Accessibility Report

Homes NSW Goulburn Development
38-42 Gerathy Street,
Goulburn NSW 2580

Project: Homes NSW Goulburn Development, 38-42 Gerathy Street
Document Type: Accessibility and Livable Housing Report
Our Reference: SYD224_435-3 (ACCESS & LHA) CM

drawing title
Ground level plan

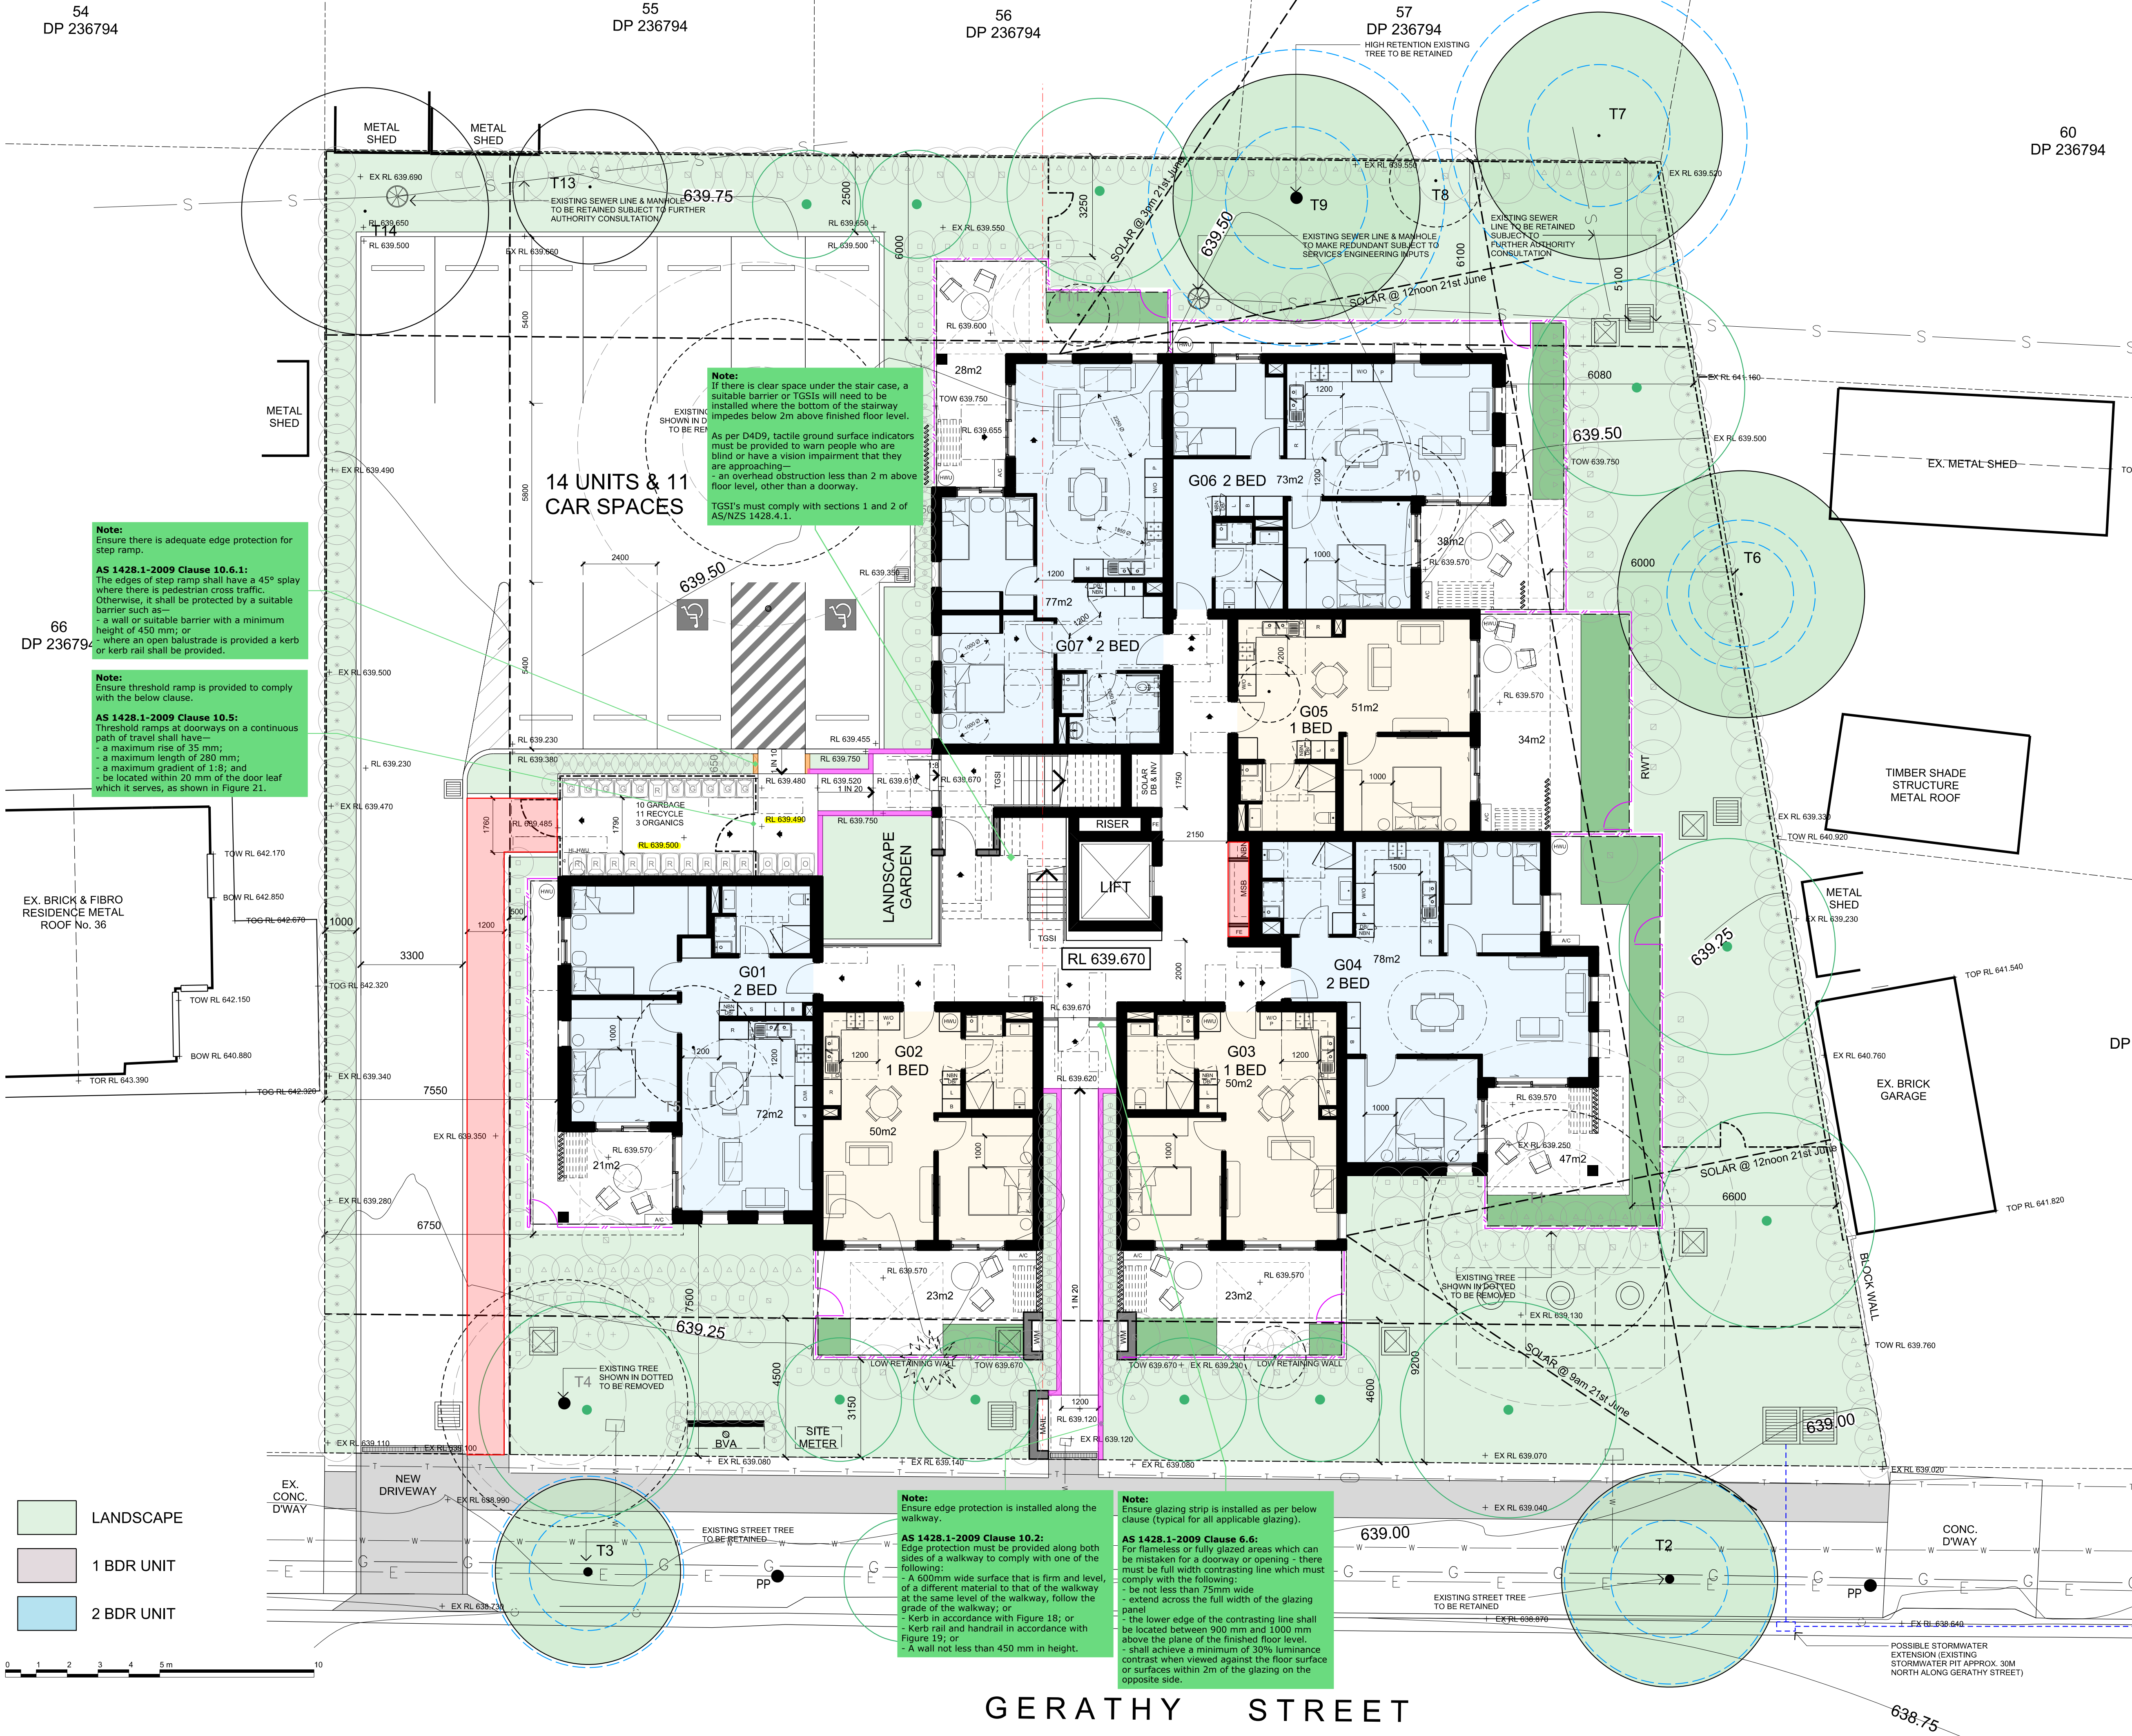
Areas highlighting in red and associated accessways have been afforded the concession under D4D5 based on the health or safety risk and therefore access for people with disabilities need not be provided to these areas (typical on all drawings).
